ADDENDUM

Project Name:	Kosciuszko Middle School Toilet Room Upgrades	Addendum No:	One (1)
Project Number:	16-118	Issue Date:	April 29, 2016
Project Location:	Hamtramck, Michigan

To the Contract Documents for the requested Kosciuszko Middle School Toilet Room Upgrades

A. REFER TO WALL SECTIONS AND INTERIOR ELEVATIONS FOR ADDITIONAL INFORMATION.

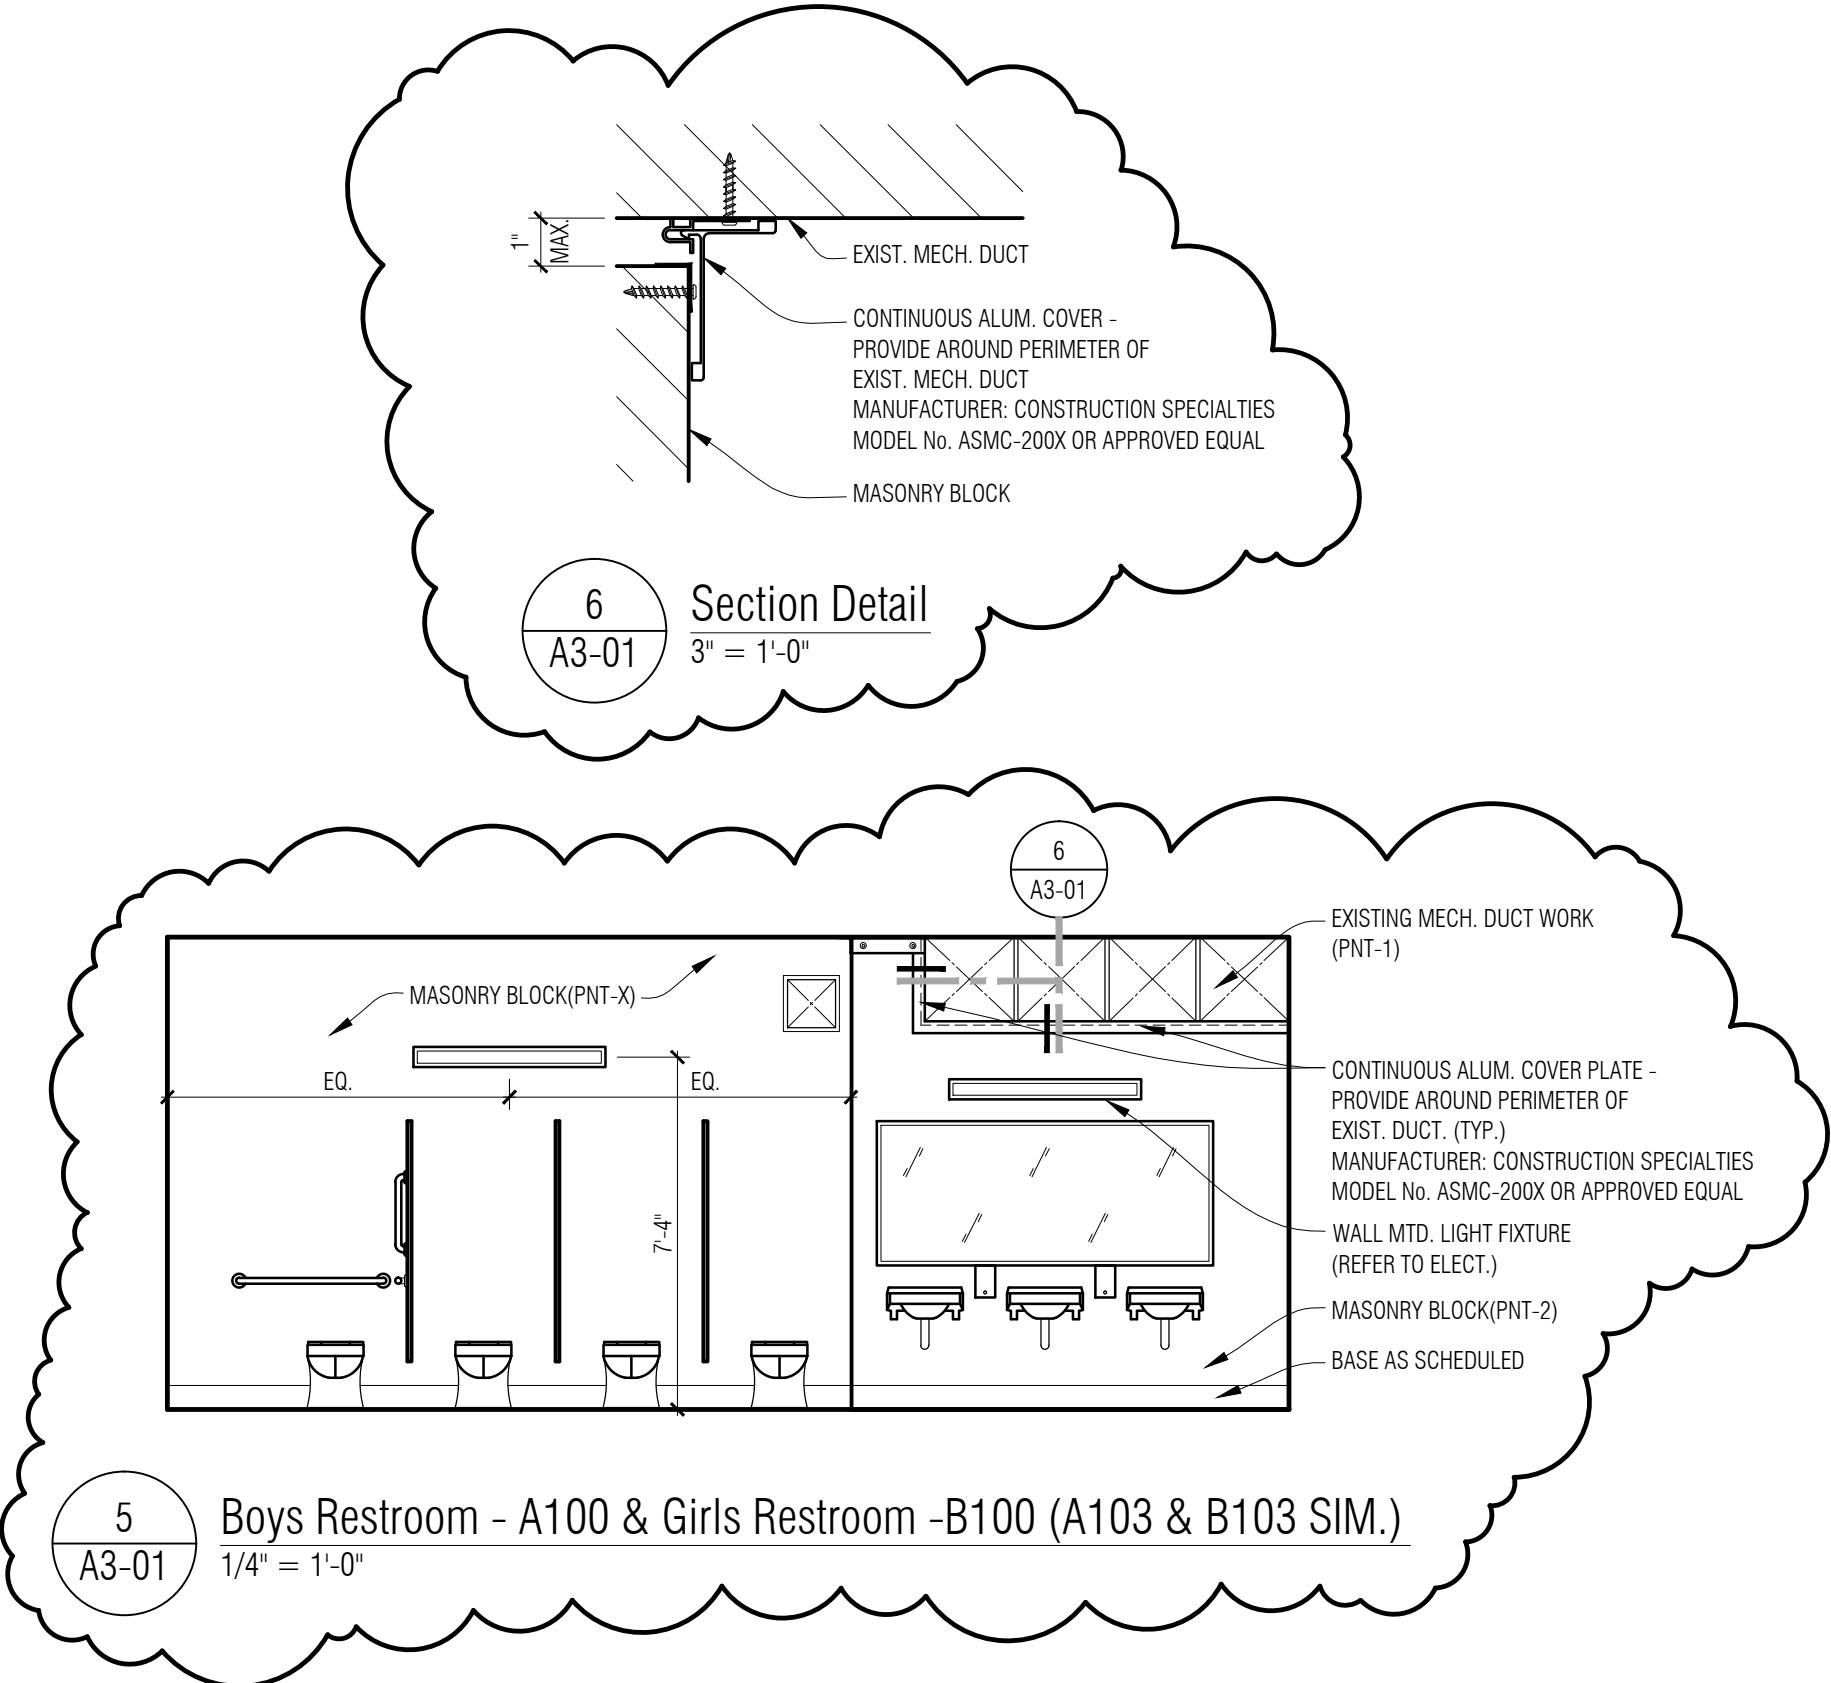
Item A1 Drawing A0-04; Schedules, Door, Frame and Wall Types (revised and reissued this Addendum)
A. Revised Room Finish Schedule as indicated
B. Added signage schedule and details

A3-01

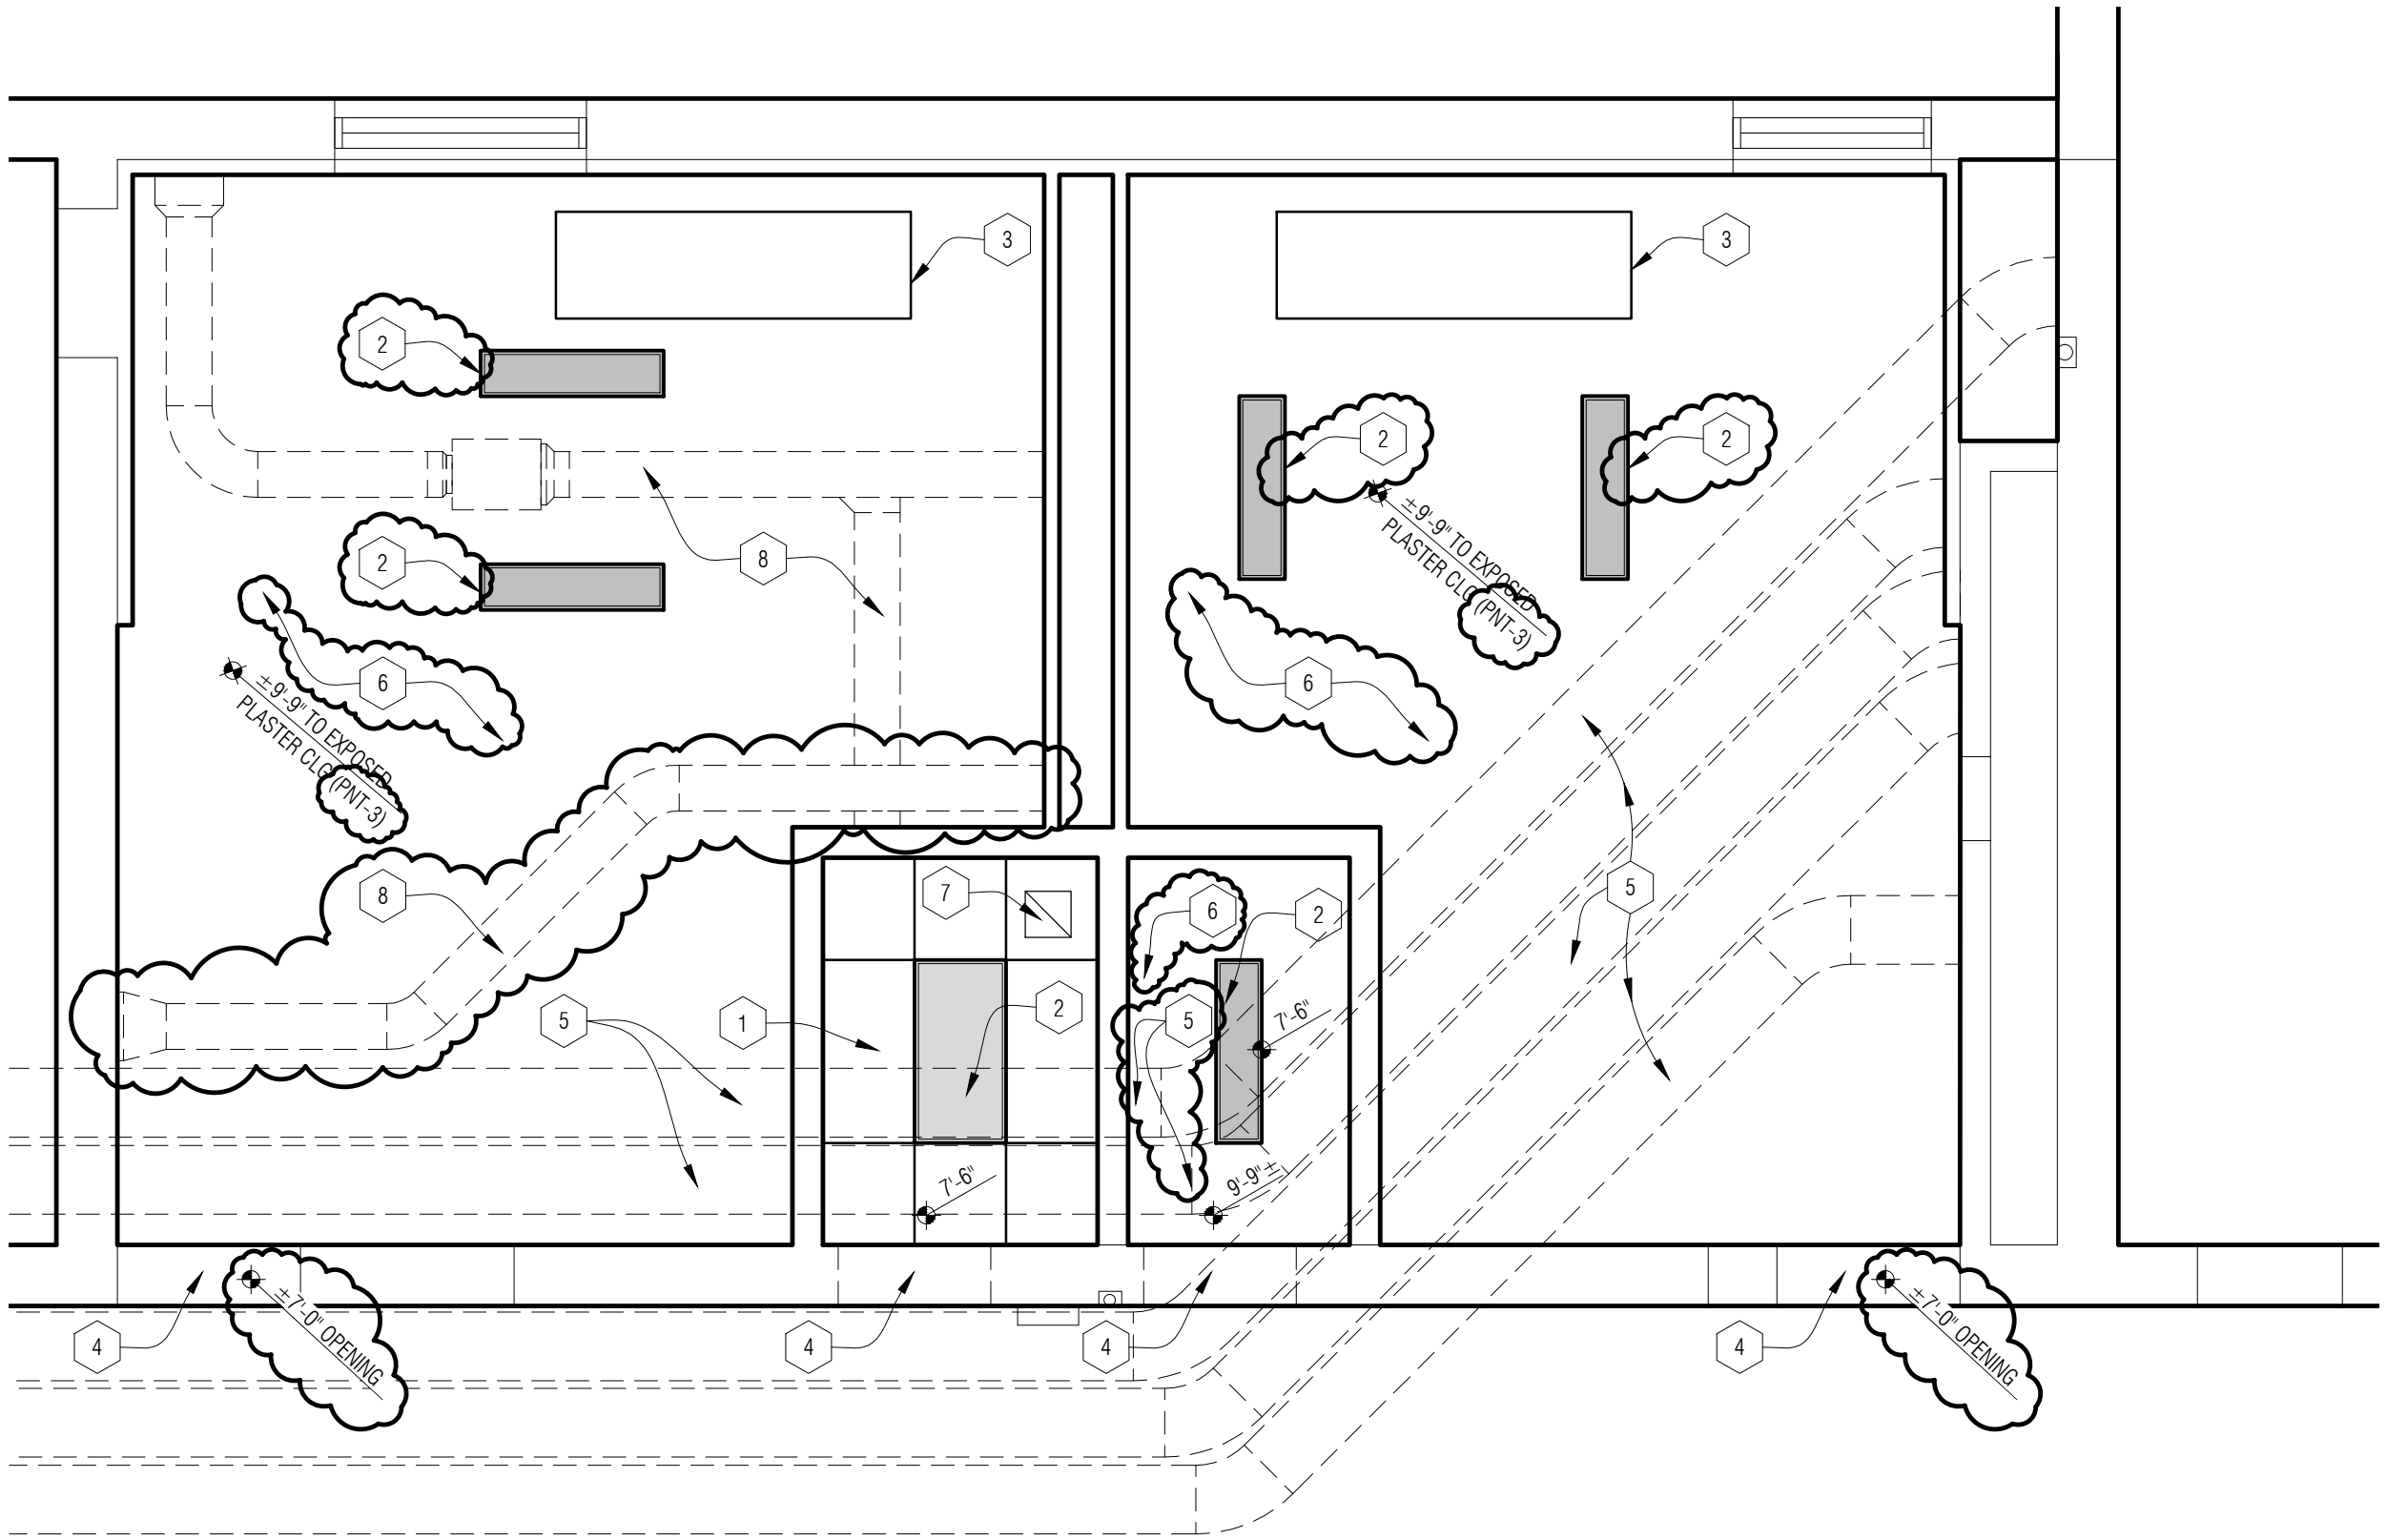
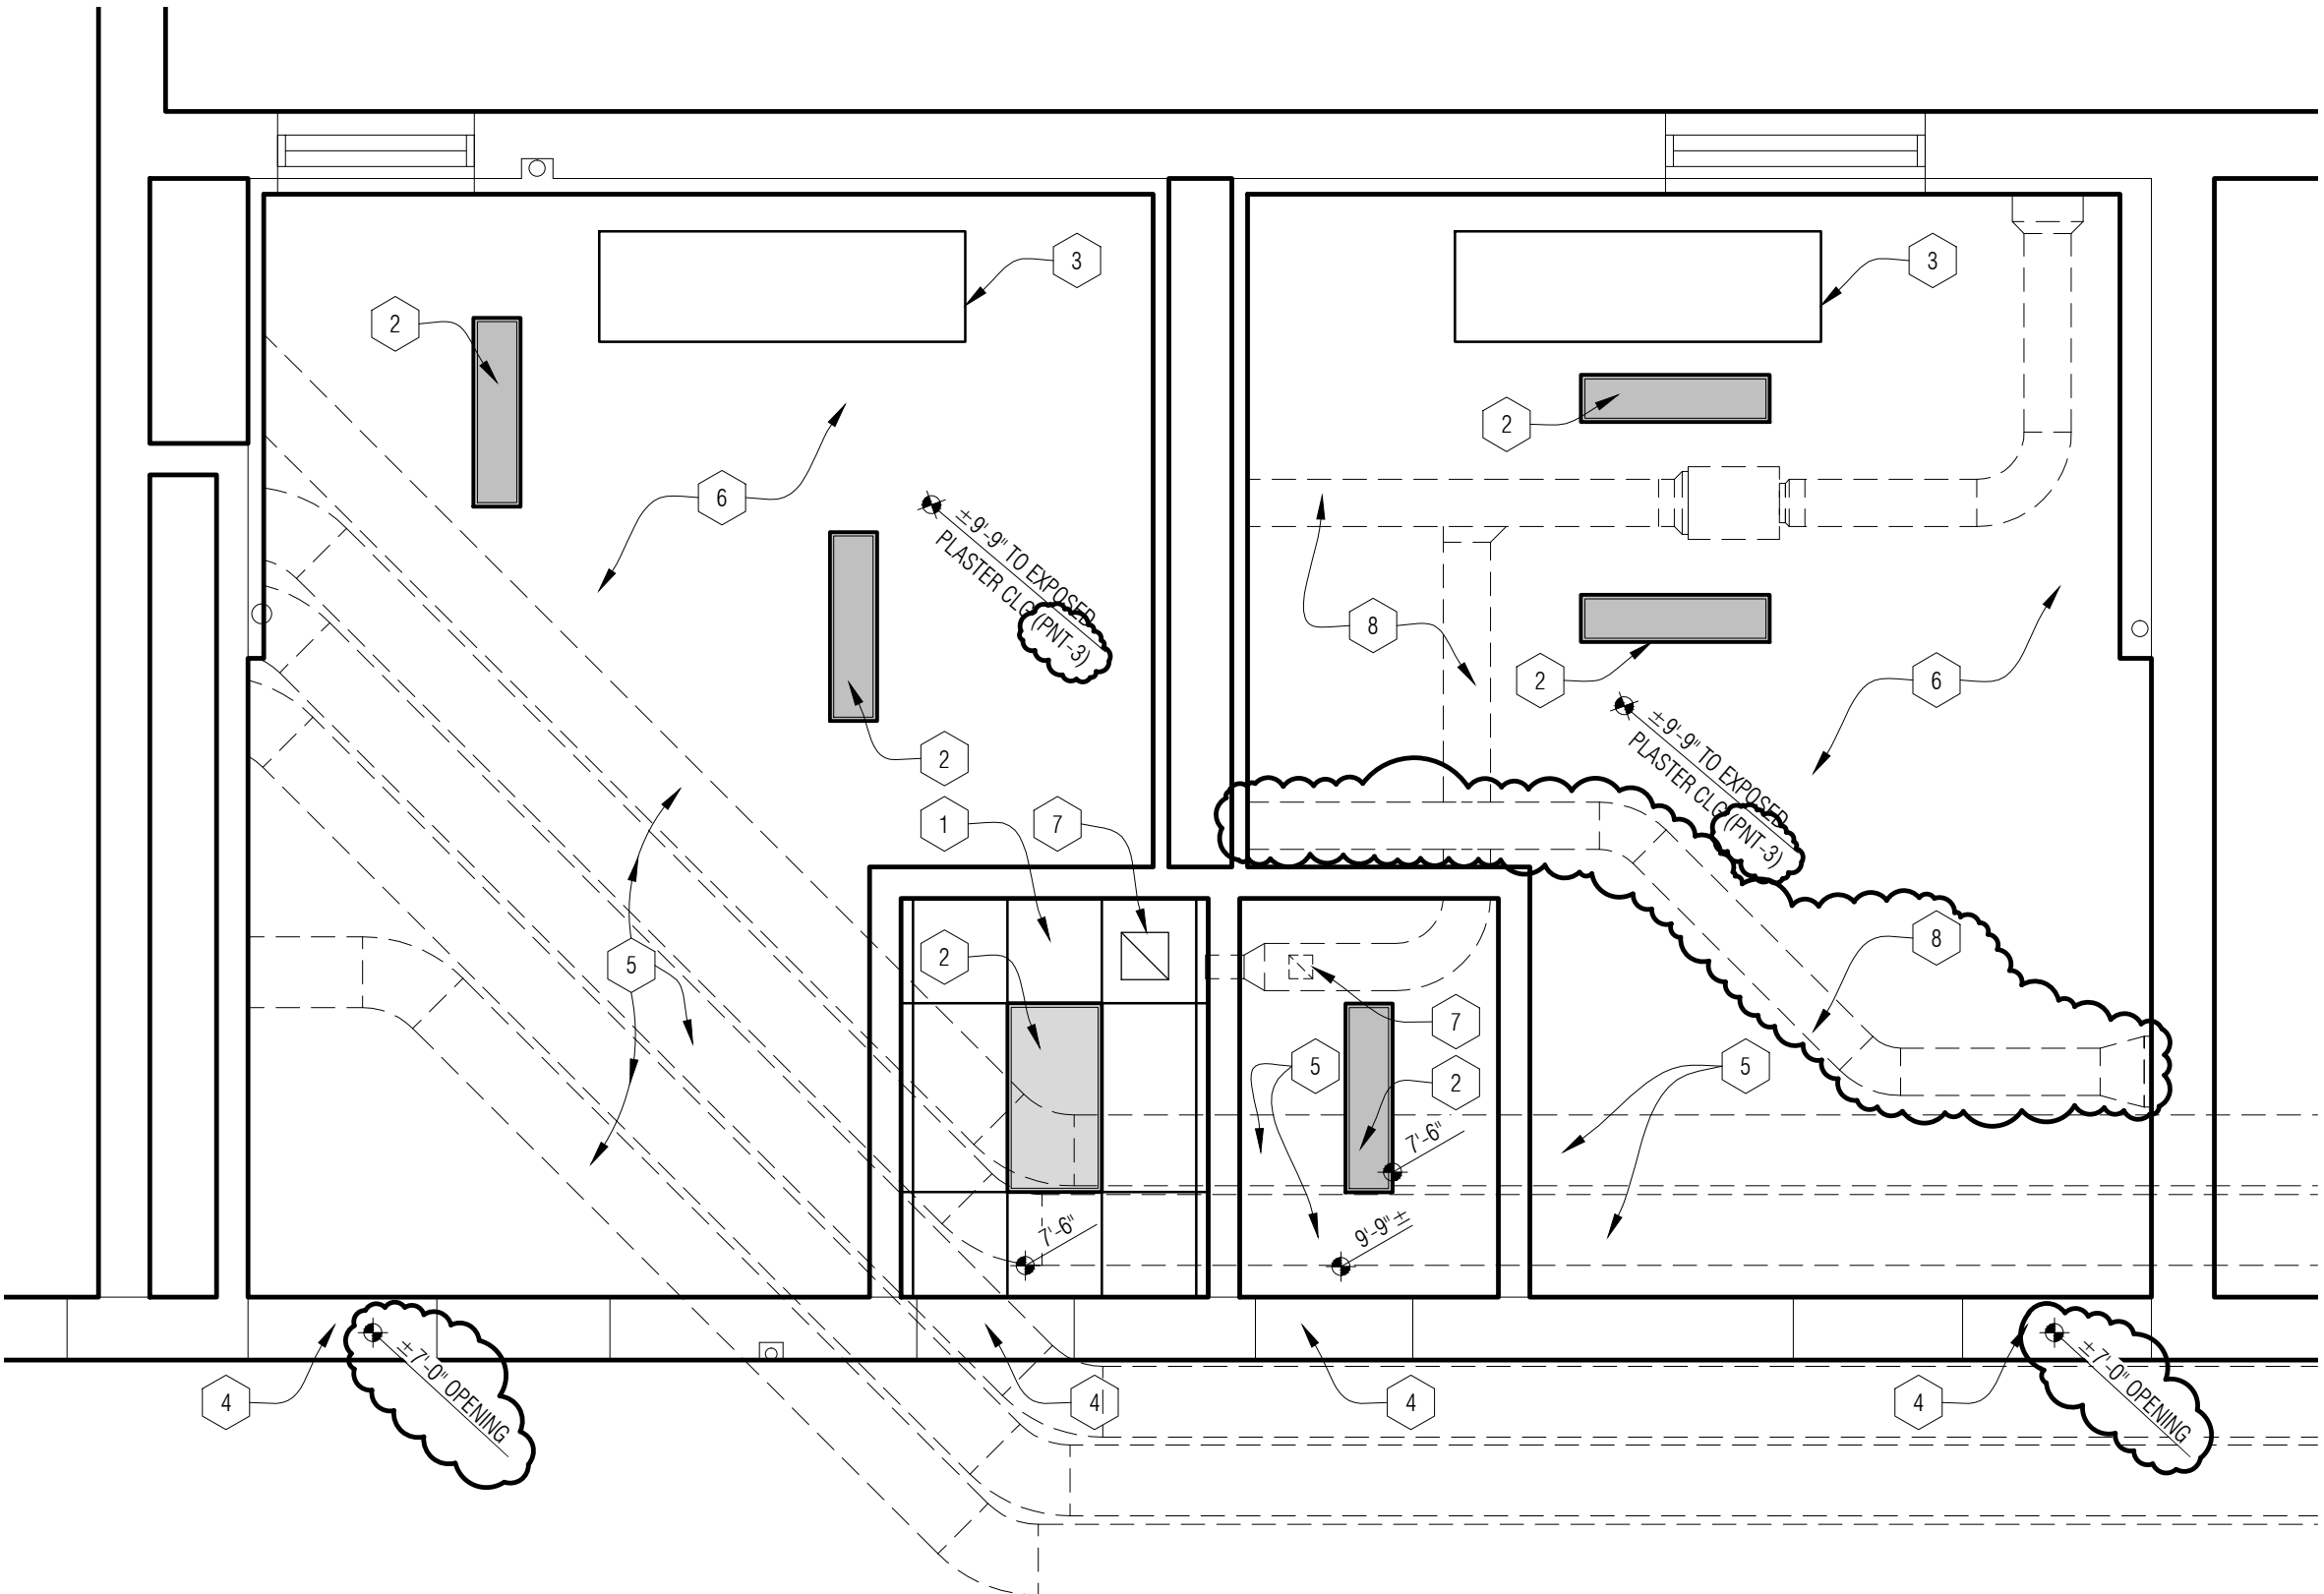
Item A2 Drawing A3-01; Partial New Work Floor Plans (revised and reissued this Addendum)
A. Revised floor plans as indicated
B. Added interior elevation
C. Added section detail 6/A3-01
